TECHNICAL STAFF REPORT

Case No./Petitioner: PB 420 – Montevideo Crossing Royal Farms
Mark Levy, MIT-Montevideo, LLC

Request: For the Planning Board to approve the Optional Design Project (ODP) in a Commercial Redevelopment (CR) Overlay District for Royal Farms at Montevideo Crossing in accordance with Section 121.1.H of the Zoning Regulations.

Exhibit B

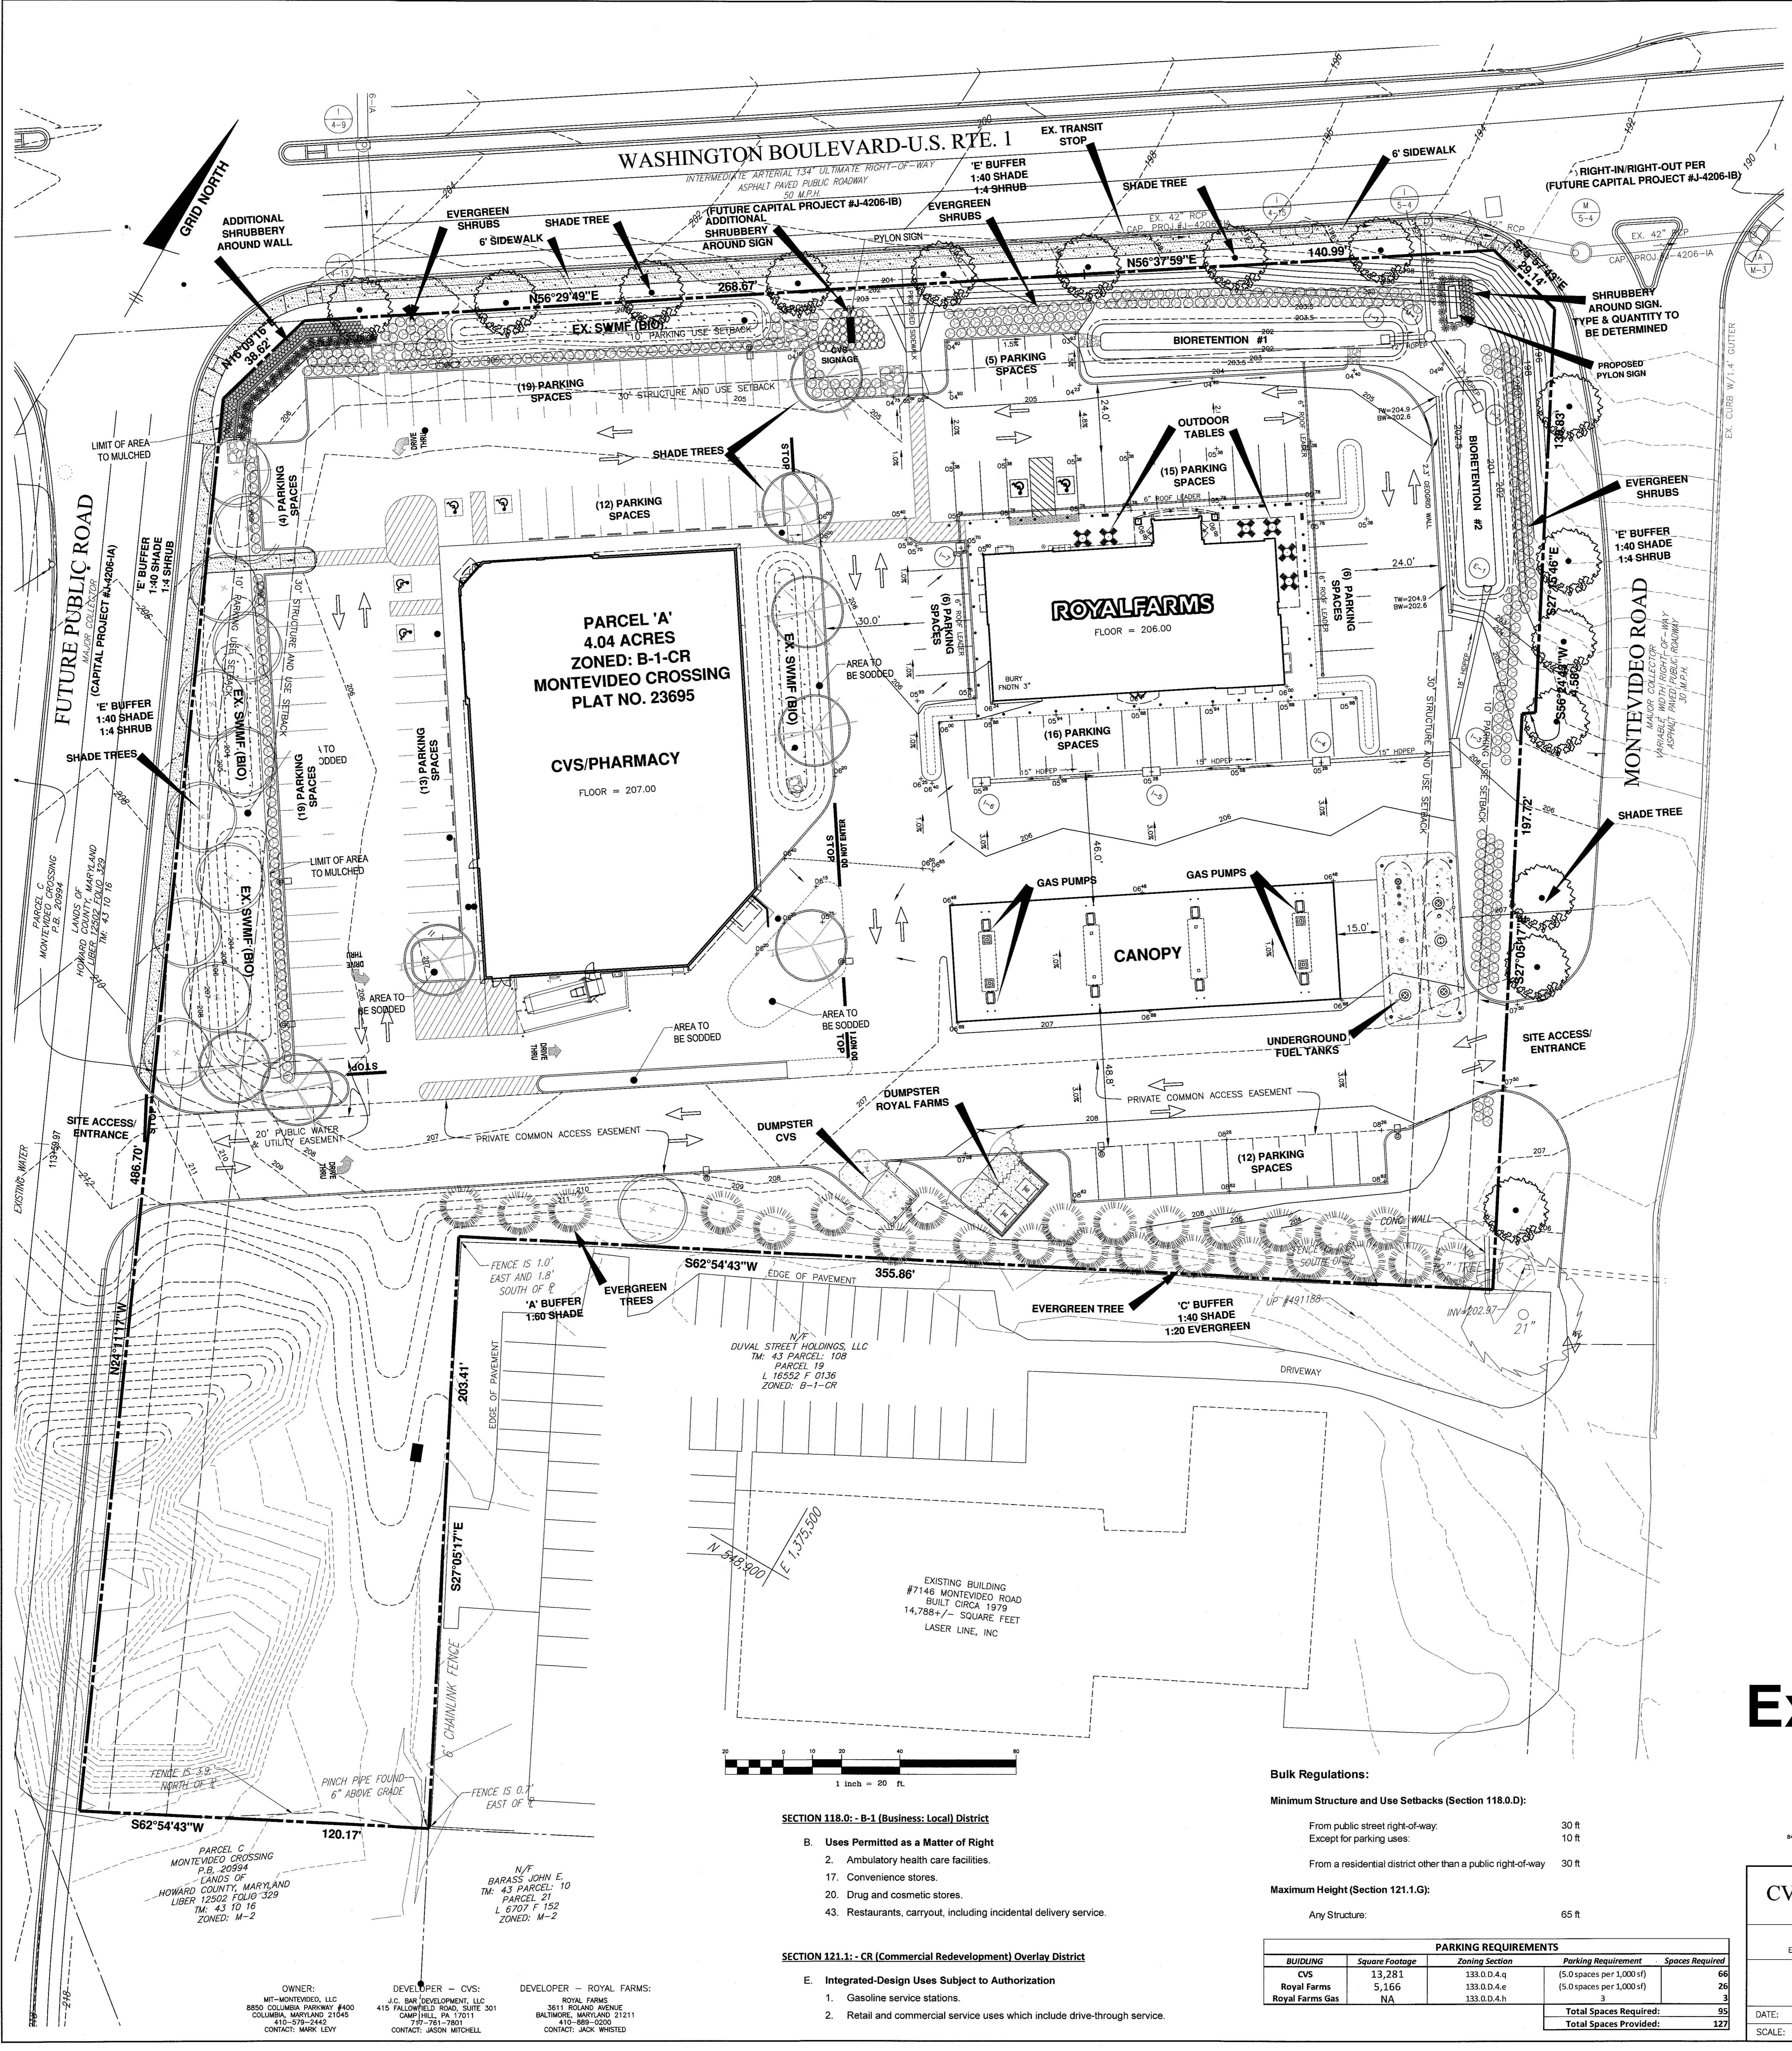
Site Improvements – The proposed Royal Farms convenience store is 5,166 SF, orientated towards Washington Boulevard, in alignment with CVS; with motor vehicle multi-purpose dispensers (MPDs) located behind. 127 shared parking spaces are accessed from Montevideo Road and New Montevideo Road with two-way internal movement along the site's perimeter and between buildings. Sidewalks with direct access to the site are proposed along new Montevideo Road and Washington Boulevard, with internal crossings to facilitate pedestrian movement. See Exhibit B.

The site complies with the Route 1 Manual design standards. The MPDs are located behind the Royal Farms convenience store to allow the building facade to align with CVS. Two-way, uninterrupted vehicular drives connect new Montevideo Road with Montevideo Road and internal movement is directed by traffic signs. Sidewalks provide pedestrian access mid-way along Washington Boulevard, in close proximity to the transit stop and on Montevideo Road perpendicular to CVS entrance. Tables are provided for an outdoor dining area and landscaping complies with applicable regulations.
